SOUTH WEBER CITY PLANNING COMMISSION AMENDED AGENDA

SOUTH WEBER CITY PLANNING COMMISSION MEETING WORK MEETING

Since the last update to the City Standards, there have been a few other needed changes identified. As changes to the City Code and City Standards need to be taken to both the Planning Commission and City Council, and adopted by ordinance, the City Staff felt it would be best to bring all of the proposed changes together at one time. The following summarize the proposed changes.

Following are the proposed changes to the City Standards (**drawing portion**):

SOUTH WEBER CITY CORPORATION
PUBLIC WORKS STANDARDS
PUBLIC ROADS - SOUTH WEBER DRIVE & SOUTH BENCH DRIVE
TYPICAL ROADWAY CROSS SECTION DETAILS

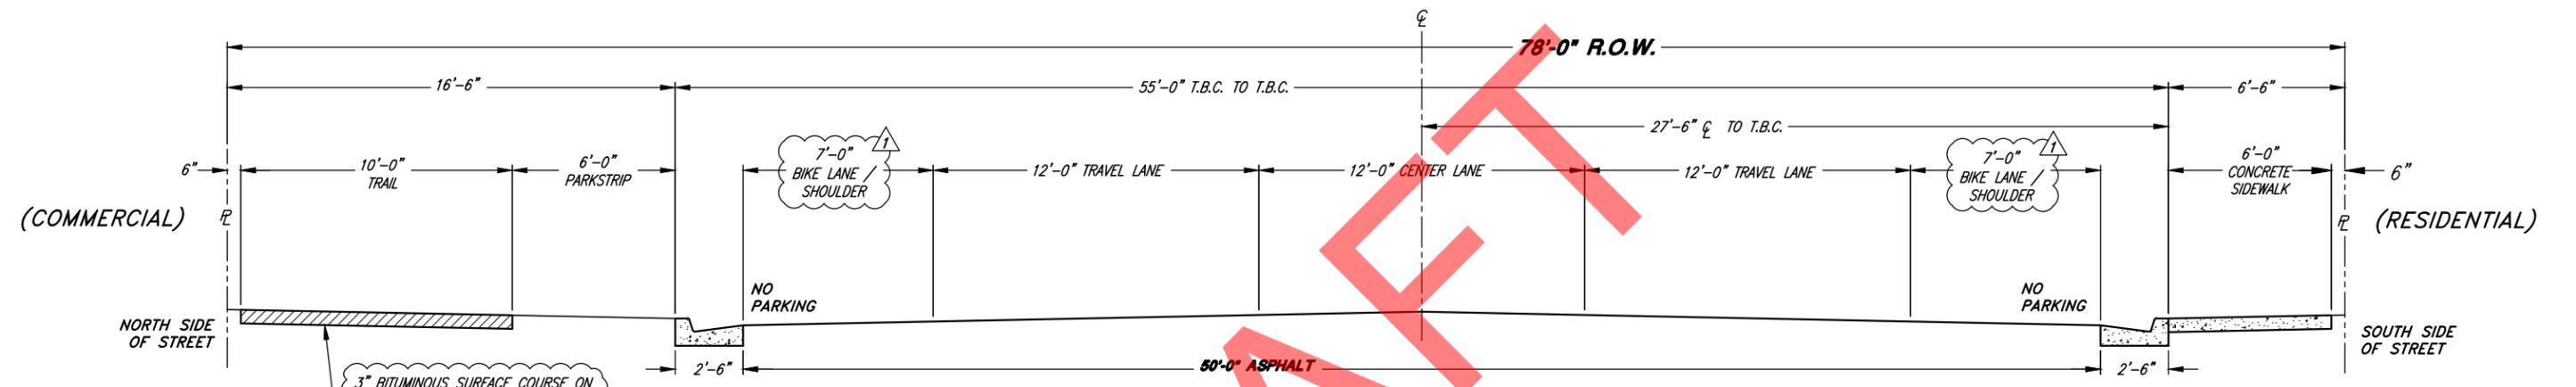
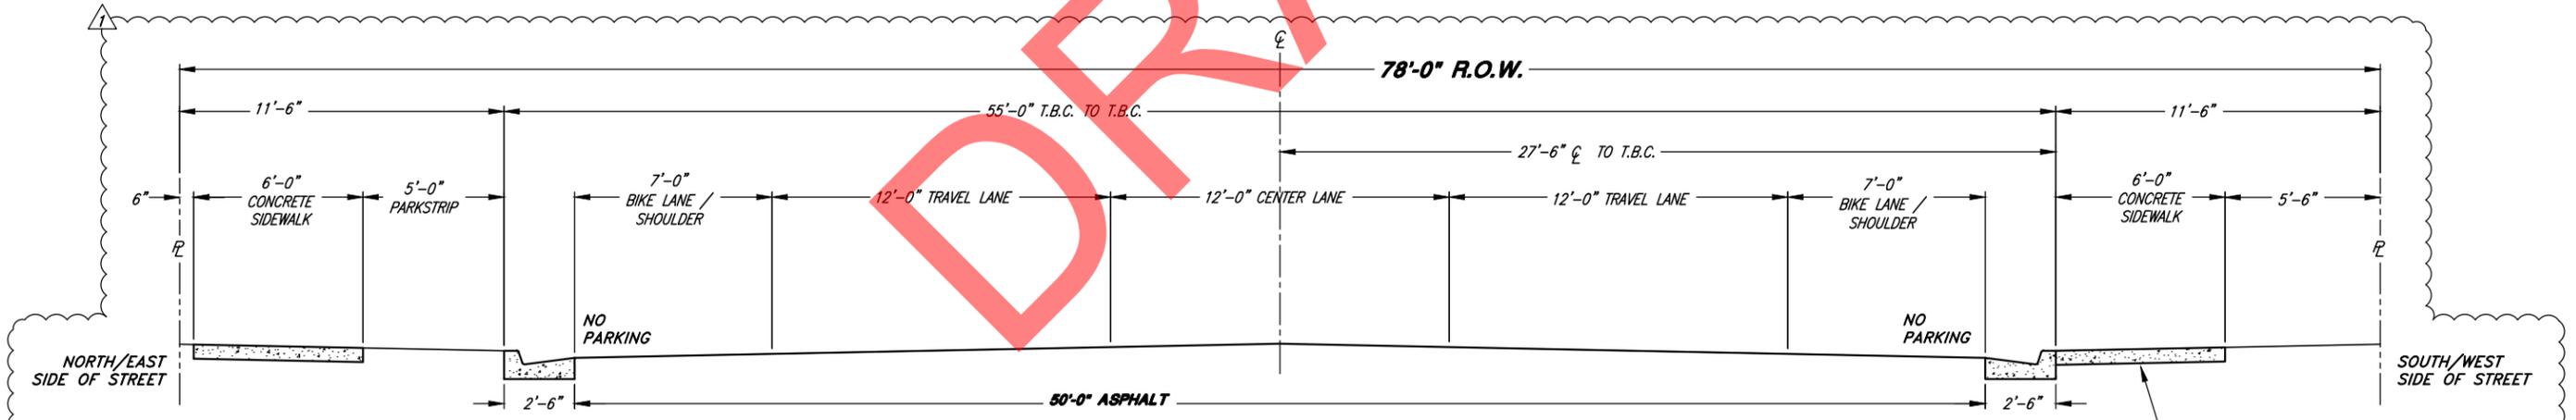
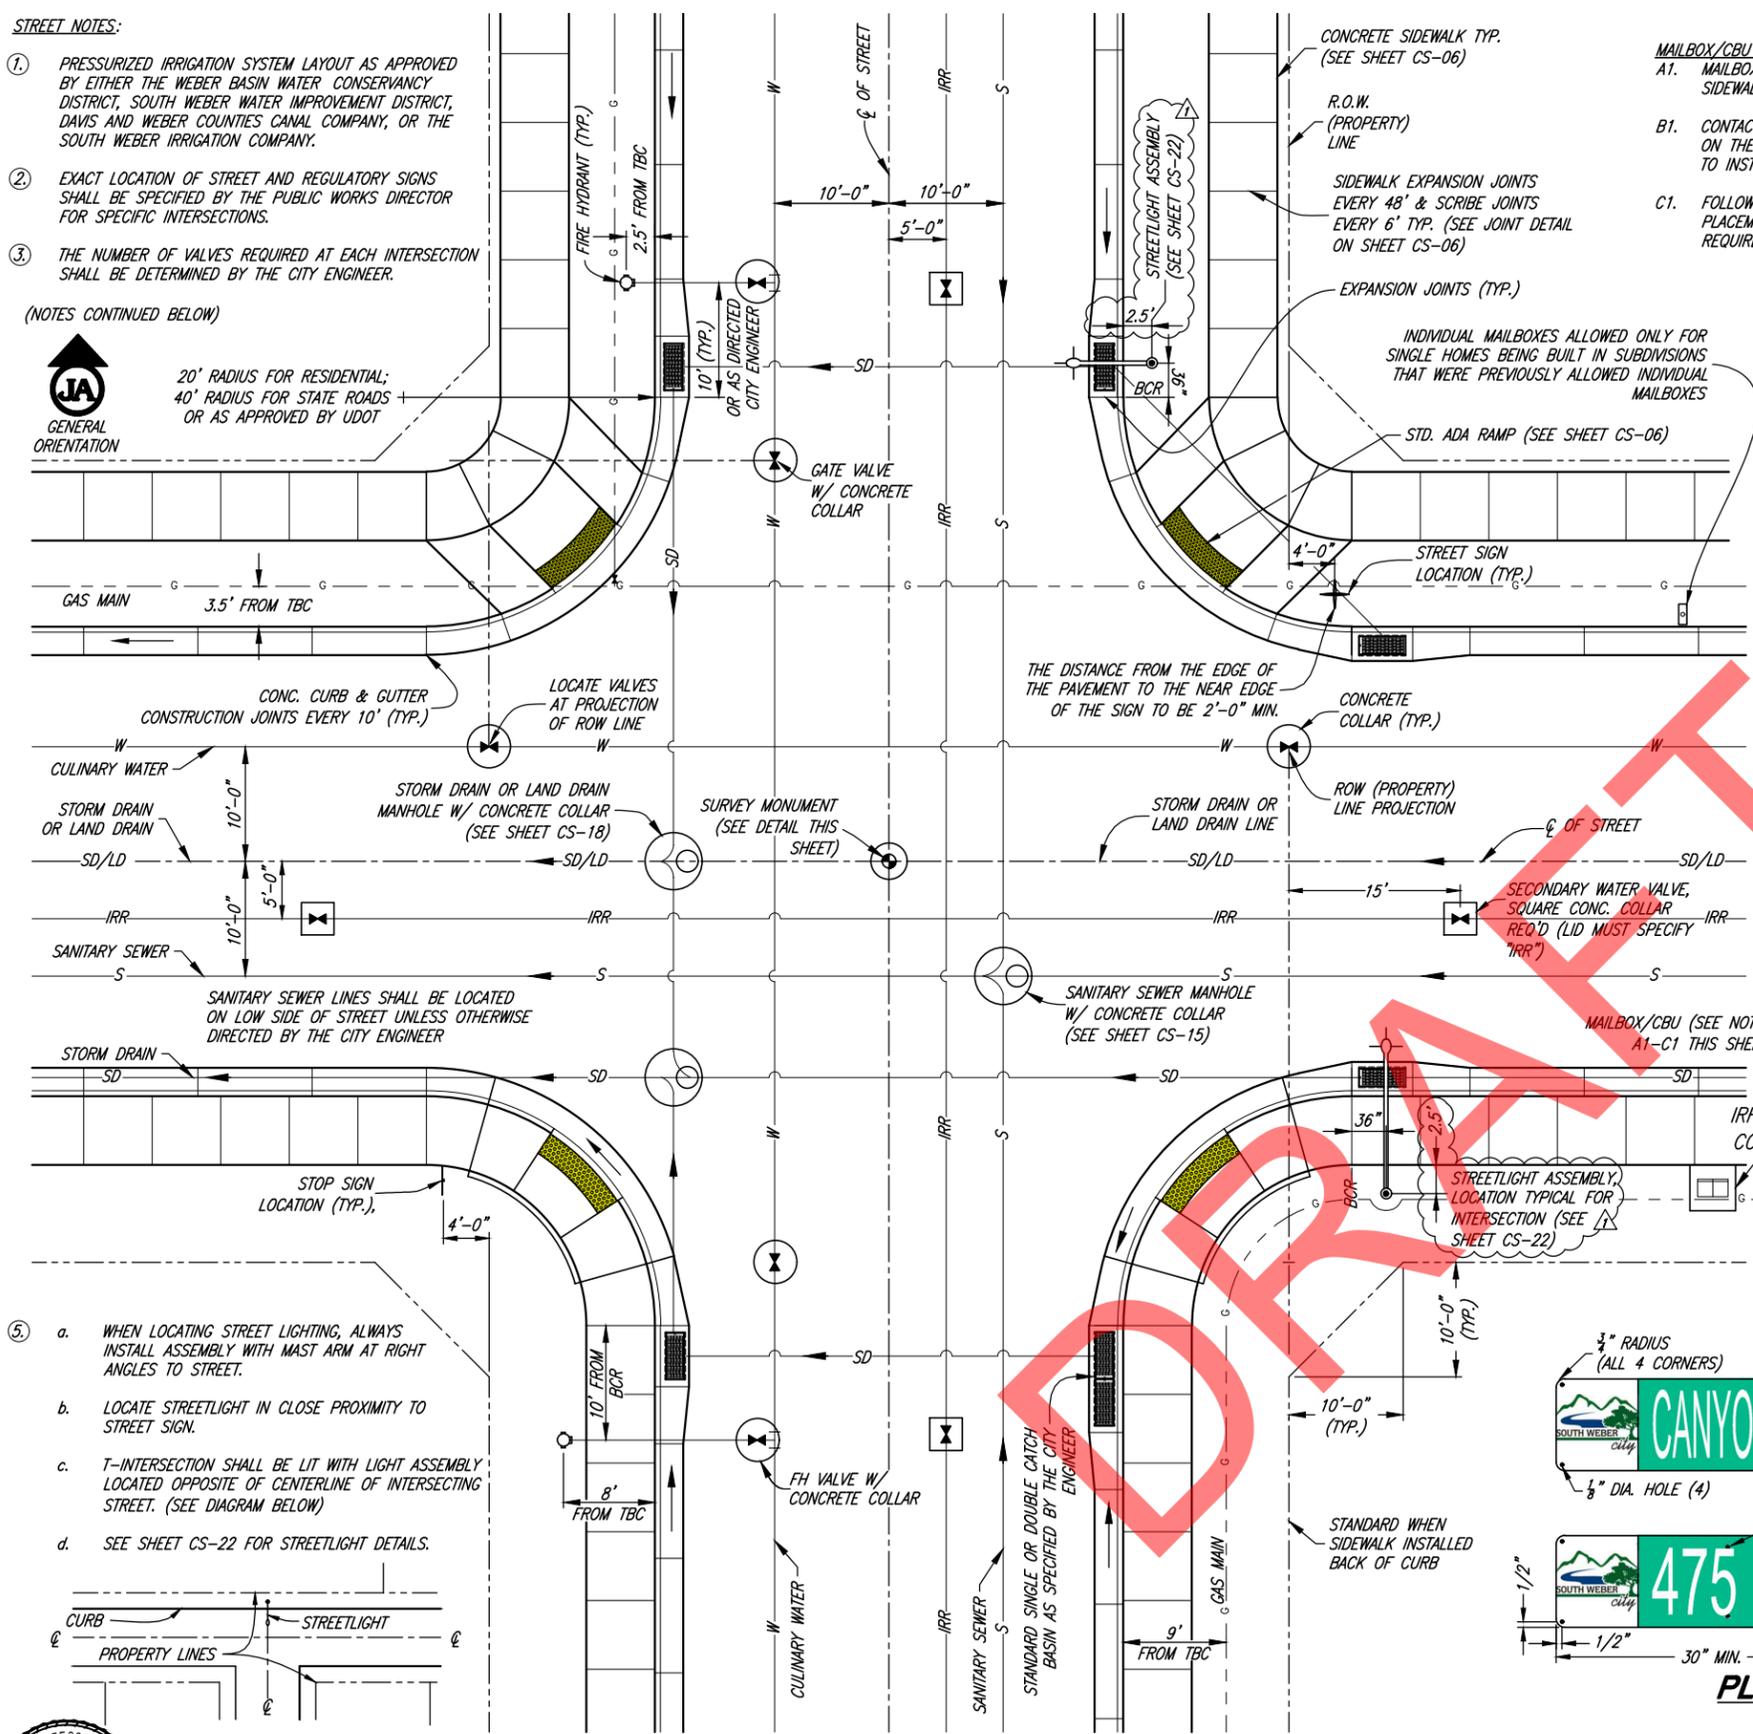
5. Cover Sheet – Updated personnel and revision text to “October 2017 – Rev. 1, February 2019”
6. There are several sheets that have been updated based on comments received from the Division of Drinking Water. These revisions have been made in order to show greater compliance with the DDW rules, but should not be considered fundamental changes.
7. CS-02 – Added tolerance of 0.5% +/- on cross slope
8. CS-02 – Added requirement for the inspector to give written approval before pavement is installed
9. CS-03 – Old Fort Road was changed to South Bench Drive
10. CS-03 – The previous 70' Old Fort Road cross section was removed and replaced with the current 78' South Bench Drive cross section
11. CS-03 – The shoulder can be left as a shoulder, or designated as a dedicated bike lane

SOUTH WEBER CITY CORPORATION
PUBLIC WORKS STANDARDS
PUBLIC ROADS - TYPICAL INTERSECTION & STREET DETAILS

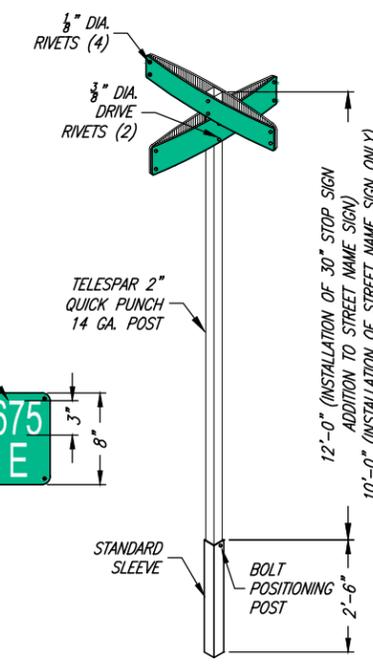
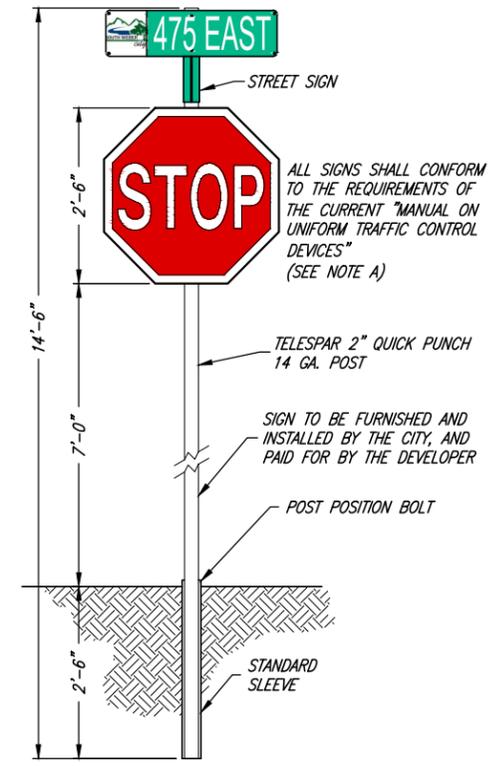
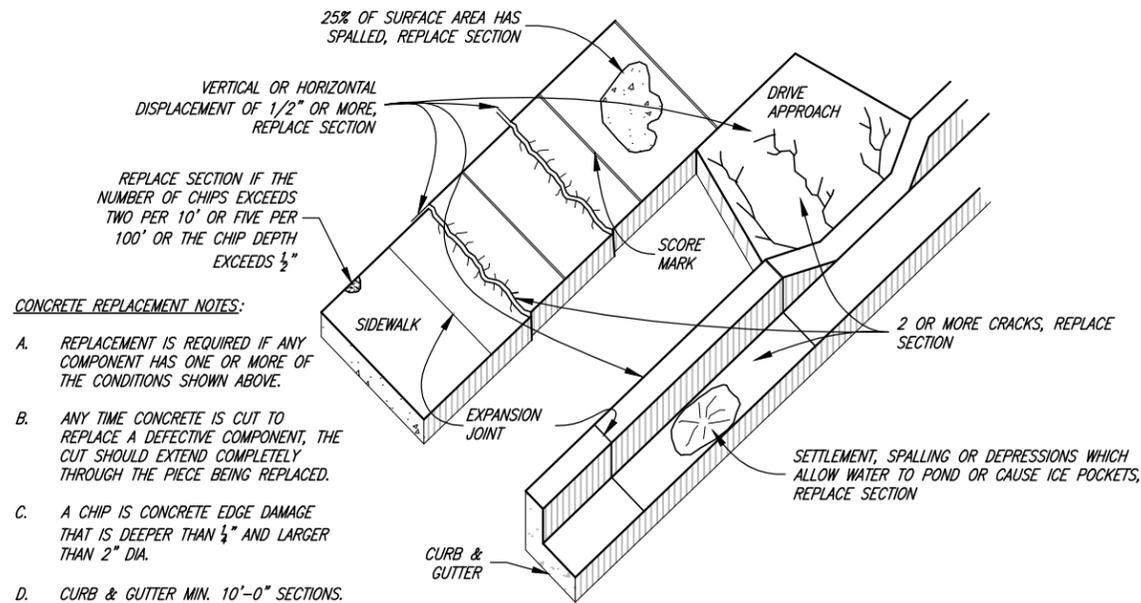
12. CS-04 – A general detail for a concrete utility collar was included, and all other collars reference this detail
13. CS-05 – If cutting the pavement on a road that has been paved or overlaid in the last 10 years, the patching requirements become much more in depth to help protect the life of the road.
14. CS-06 – Added notes for a better understanding of the requirements on curb and gutter and sidewalk
15. CS-07 – Added cul-de-sac streetlight and reference
16. CS-11 – Contractor is responsible to supply all meters 1 ½” or greater
17. CS-22 – This is the sheet that implements the new streetlight standards. As it will be the City’s responsibility to select and install the lights, we felt it was best to give general direction in the Standards, and not show specific lights.

GENERAL - STREET LIGHTING STANDARDS

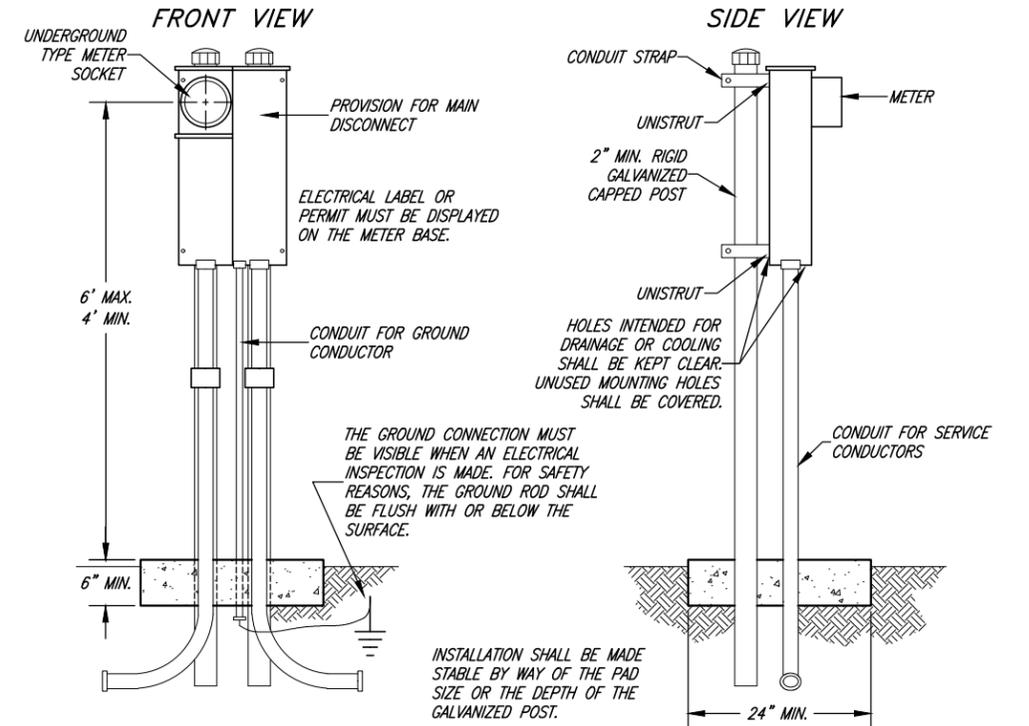
The City will be requesting proposals from various streetlight suppliers and through that process will select the exact streetlight that will be installed. This sheet establishes that there are three different styles of lights. Each will be used in different locations and with different spacing requirements, based on their intended use. Also listed are general requirements that the streetlights must comply with (e.g. LED, dark-sky compliant, aluminum bases painted black with a sanded aluminum city logo/text, etc.).
